UNITED STATES
NUCLEAR REGULATORY COMMISSION
REGION V
1990 N. CALIFORNIA BOULEVARD
SUITE 202, WALNUT CREEK PLAZA
WALNUT CREEK, CALIFORNIA 94596

IE Bulletin No. 80-20

FAILURES OF WESTINGHOUSE TYPE W-2 SPRING RETURN TO NEUTRAL CONTROL SWITCHES

FIGURE 1

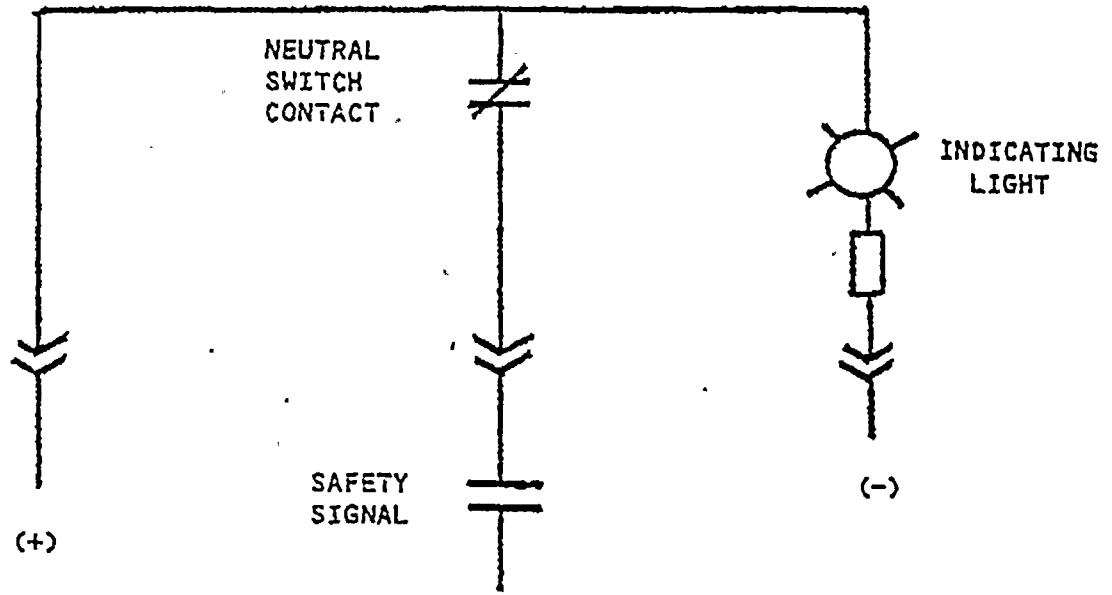
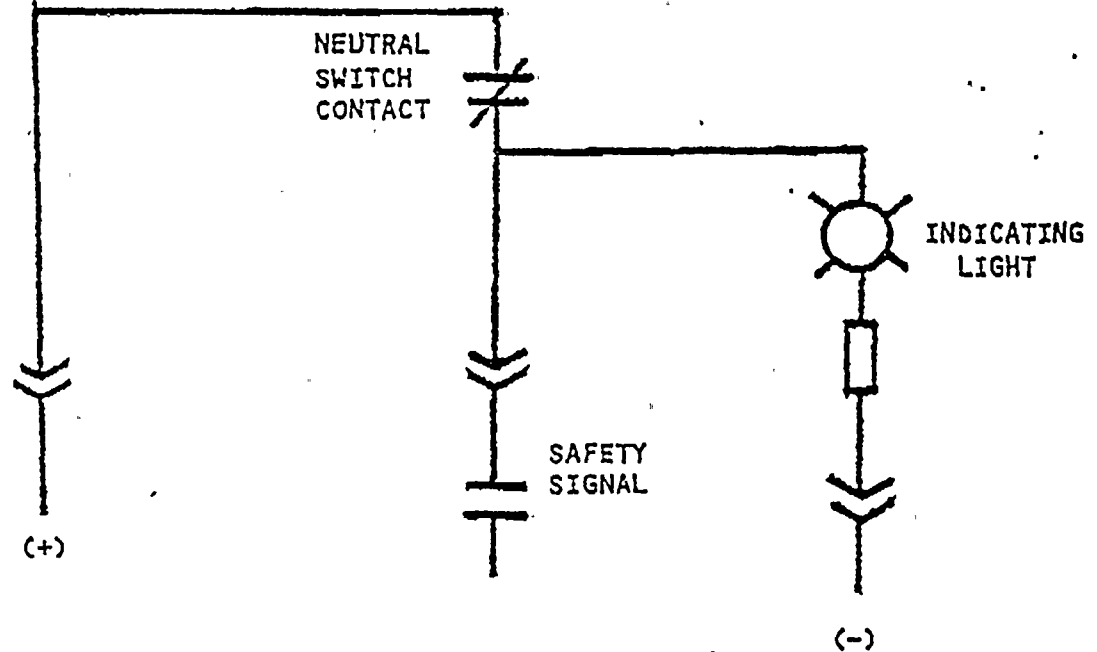
A review of this matter by Westinghouse led to the issuance of NSD Technical Bulletin No. NSD-TB-80-9 to the utility owners of all Westinghouse operating plants. The recommendations contained in the Westinghouse technical bulletin include: (i) testing the neutral position contacts of the subject W-2 switches for continuity, and (ii) rewiring of the indicating light circuit to permit the early detection of a neutral contact failure as shown in Figure 1.

Depending on how the indicating light circuit is wired, loss of continuity thru the neutral position contact of a W-2 switch could remain undetected until the equipment associated with the switch were called upon to operate. Since such a failure would be equivalent to by-passing the system associated with the switch, consideration should be given to rewiring the switches used in safety-related applications as shown in Figure 1. Such rewiring would provide an acceptable means for detecting contact failure, provided the indicating light is in the control room and readily visible by the operator. If the indicating light is not so located, consideration should be given to annunciating the neutral position contact failures at the control room to alert the operator of the inoperable status of a safety-related system. In addition, consideration should be given to adding redundant contacts to the W-2 switches or to replacing the W-2 switches with others having a more positive contact wiping action.

3. Licensees of operating plants and holders of construction permits shall describe the longer term corrective measures planned and the date by which such measures will be implemented by actual installation or by design change, as appropriate. As a minimum, the longer term corrective measures should include rewiring the indicating light as shown in Figure 1 provided the light is readily visible to the control room operator. If not, failures of the neutral position contacts should be annunciated in the control room.

REWIRING OF INDICATING LIGHT CIRCUIT OF W-2 SWITCHES
AS RECOMMENDED BY WESTINGHOUSE TECHNICAL BULLETIN NSD-TB-80-9
